FLOOR PLAN - MAIN LEVEL - 1 3
CLASSROOM ADDITION - POWER AND SPECIAL SYSTEMS
 SCALE: 1/8" = 1'-0"

FLOOR PLAN - LOWER LEVEL - 1 4
CLASSROOM ADDITION - POWER AND SPECIAL SYSTEMS
 SCALE: 1/8" = 1'-0"

LAST REV.:
 PROJECT NO.: 98-033
 DATE: FEB 17, 1999
 SCALE: AS NOTED
 TITLE:
 FLOOR PLANS -
 CLASSROOM
 ADDITION -
 POWER AND
 SPECIAL SYSTEMS

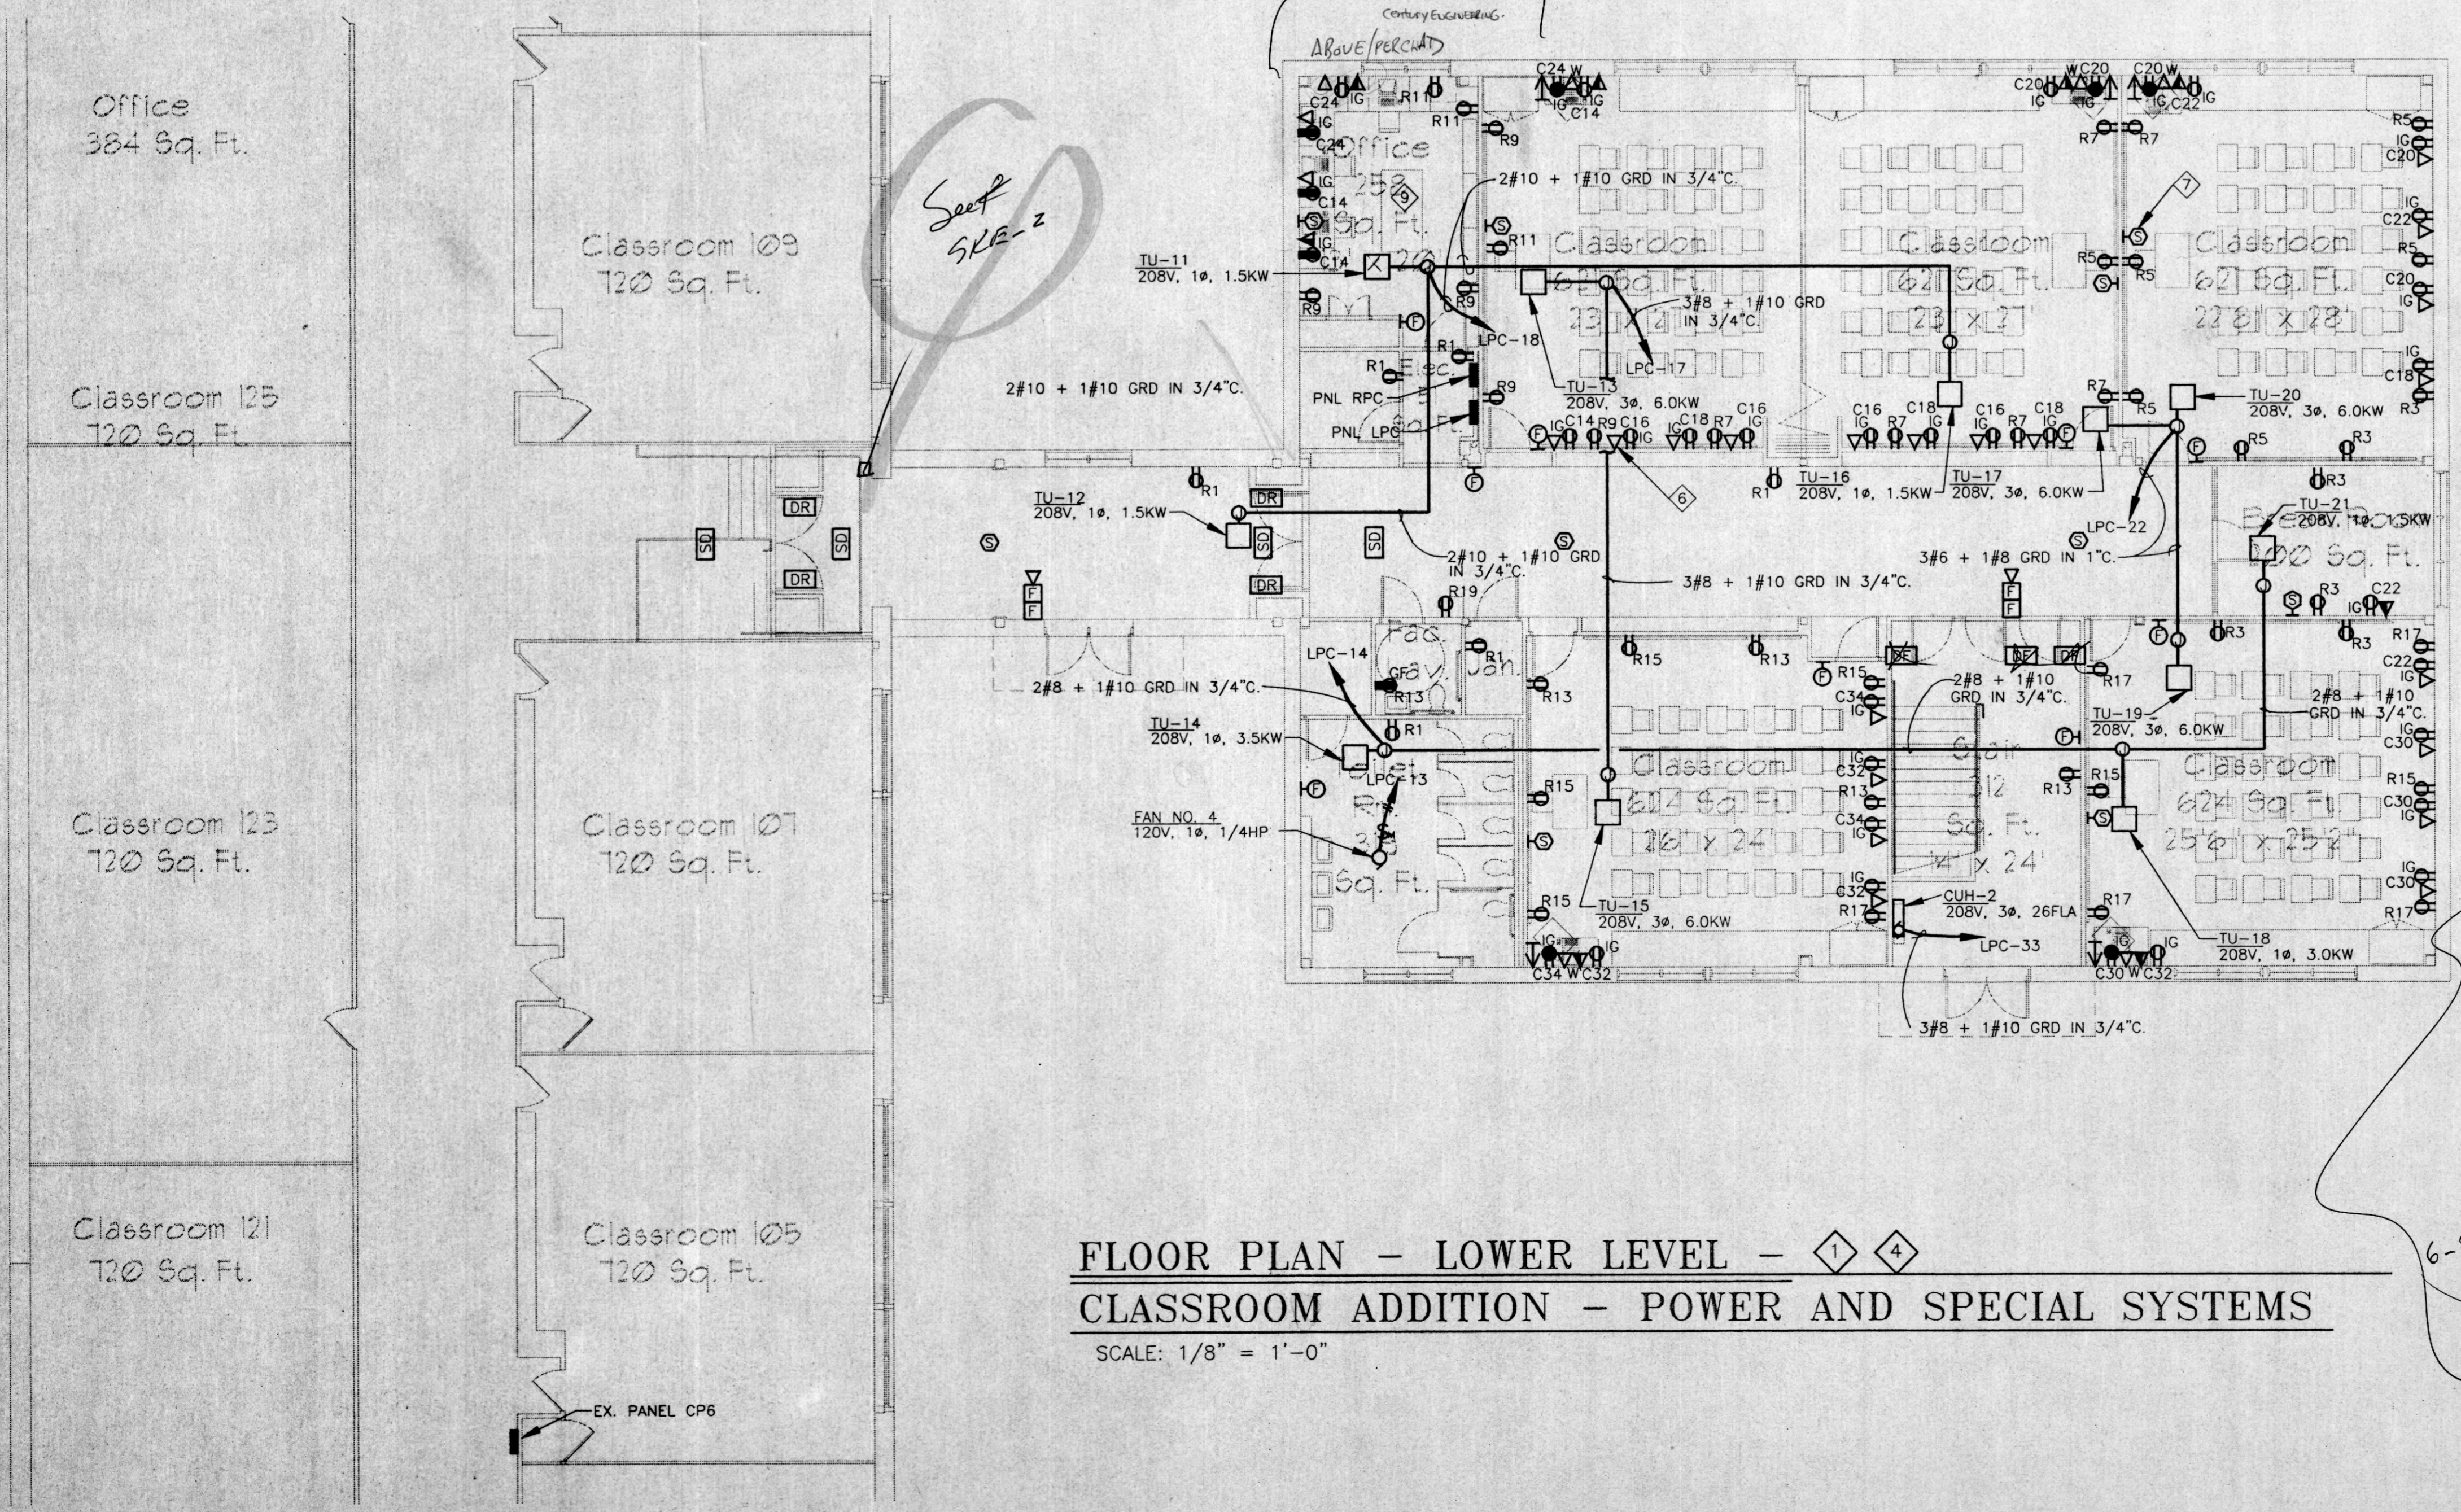
8/19/99
 Eliminate
 May floor Hold
 open
 ASPEN chad
 &
 Rubling
 6-Door's
 @ top
 stairs

See SKE-2 sheet 1
 Removal of Fire Alarm
 pull stations
